Final Environmental Impact Report
for the
Proposed Hitch Ranch Specific Plan
SCH # 2019070253

City of Moorpark
799 Moorpark Avenue
Moorpark, CA 93021

May 2022

1.0 INTRODUCTION

FIGURE 3.10-4a

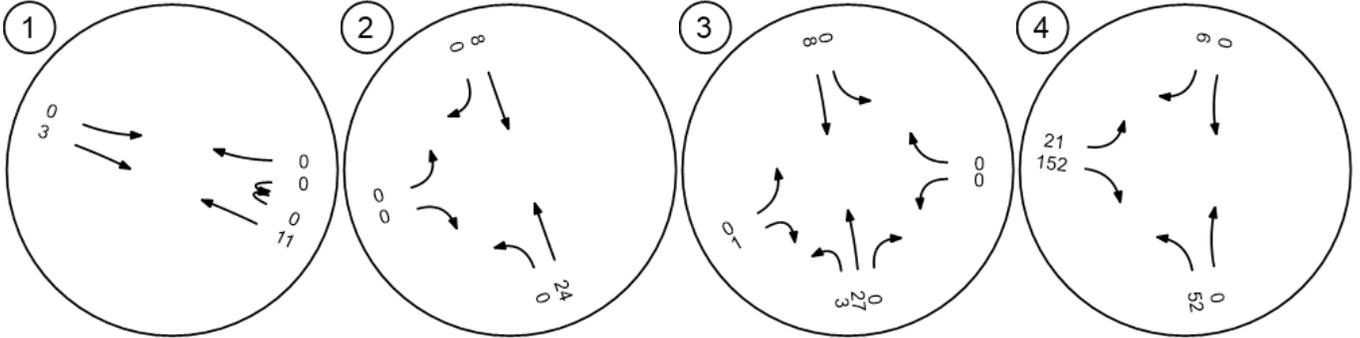
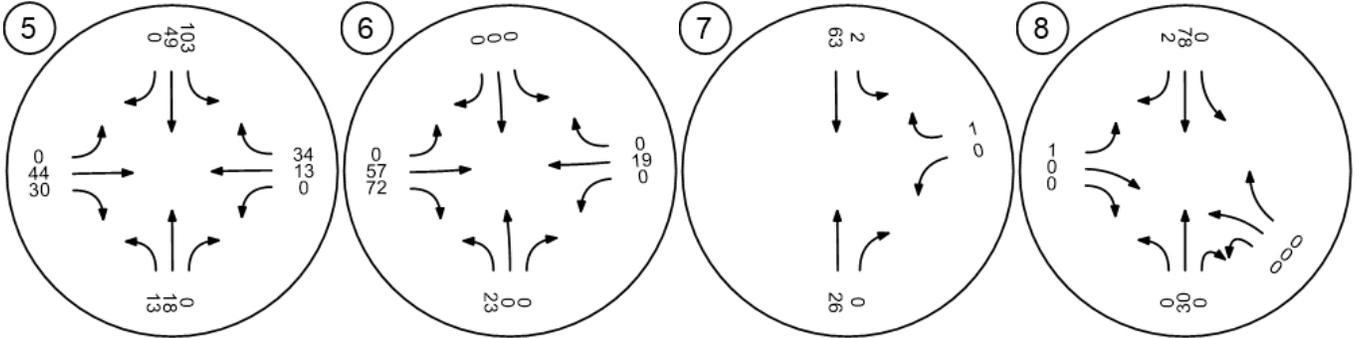
8. Note DEIR Appendix 3.10 is missing Figure 3.10-4a, as Figure 3.10-4b is included twice in consecutive pages in likely error. 9

Appendix 3.10 - Figure 3.10-4a Project Traffic Volume - Weekday AM Peak Hour is presented below.

FIGURE 3.18-3

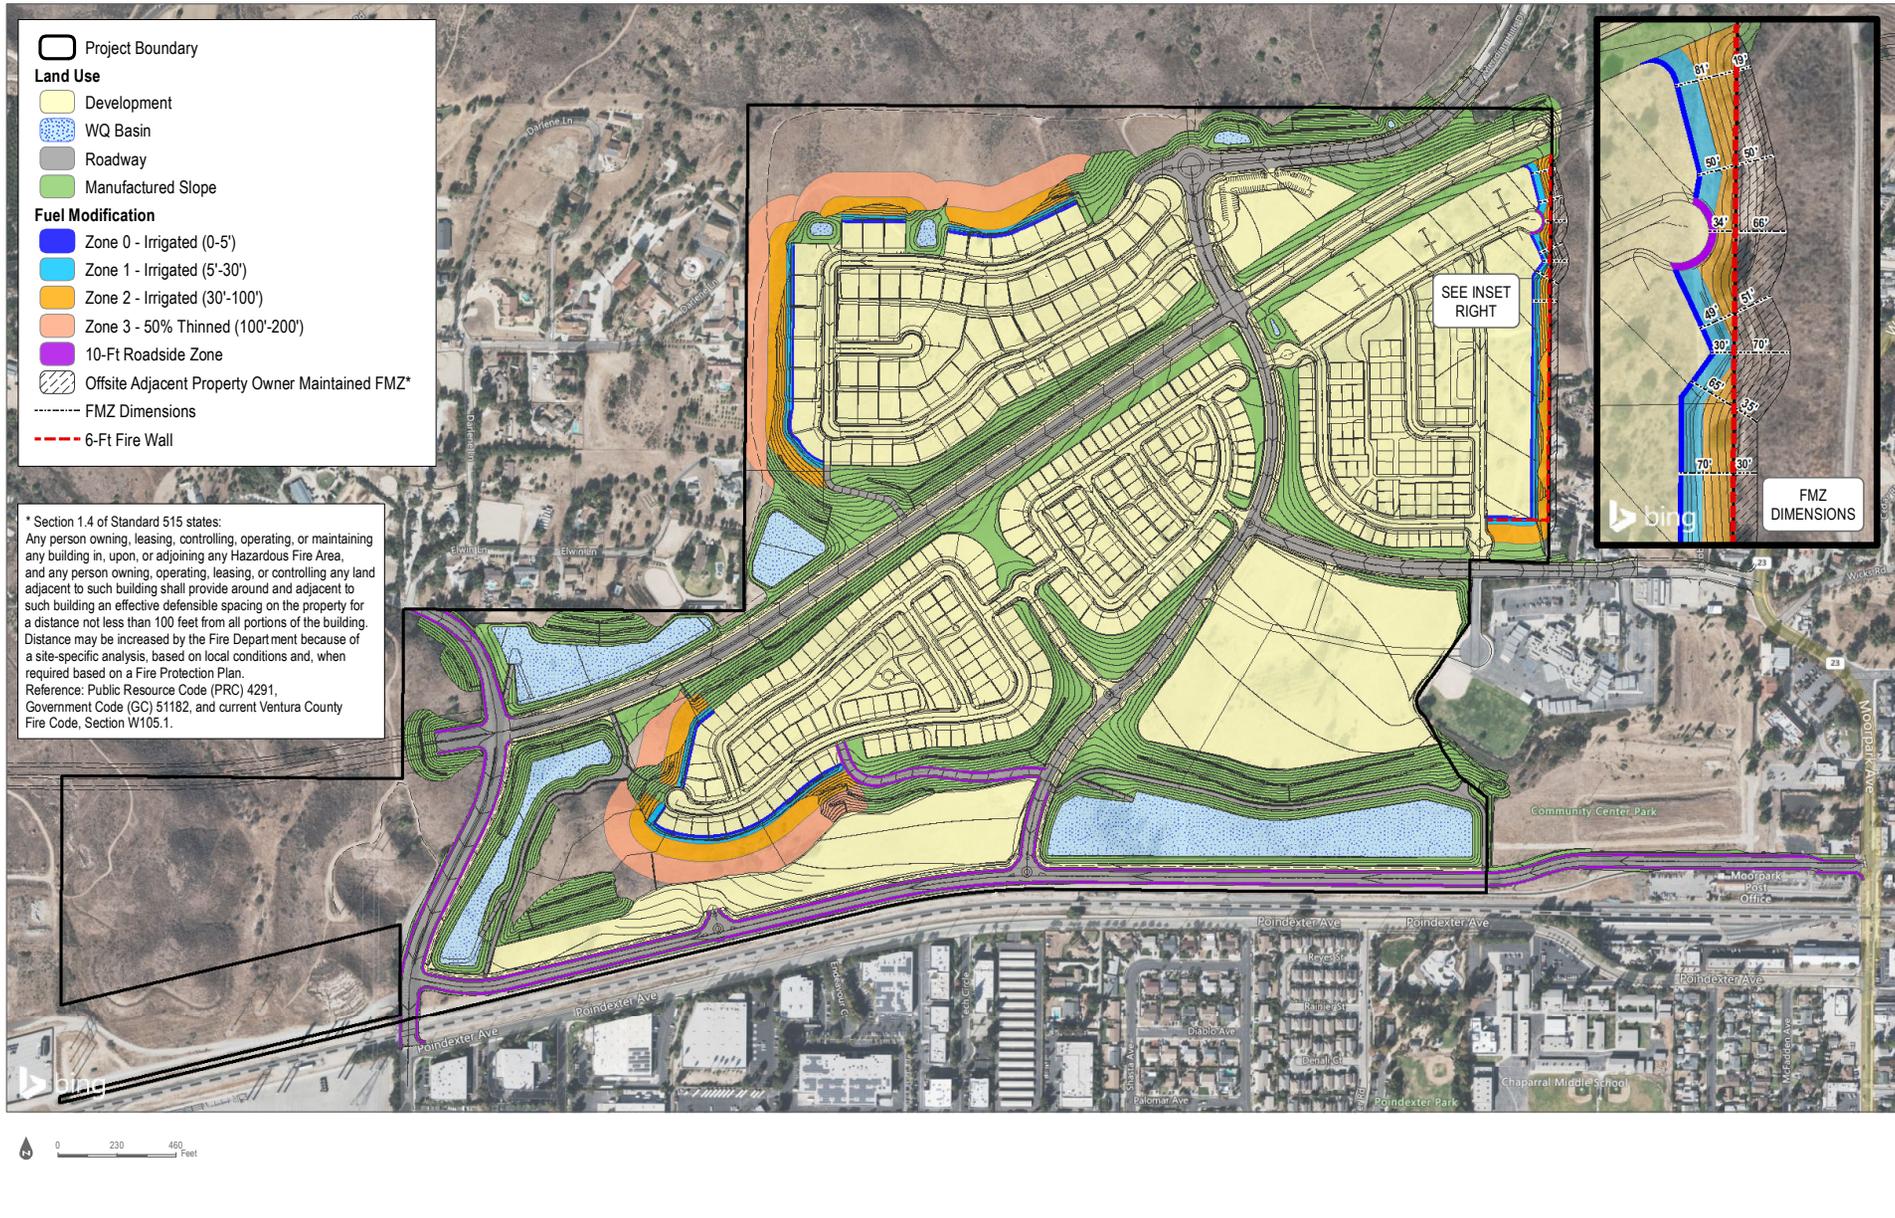
Figure 5 - The Conceptual Fuel Modification Plan is outdated due to changes in State and Local laws and regulations and should be updated.

Page 3.18-31 – Figure 3.18-3, Conceptual Fuel modification Plan has been revised.
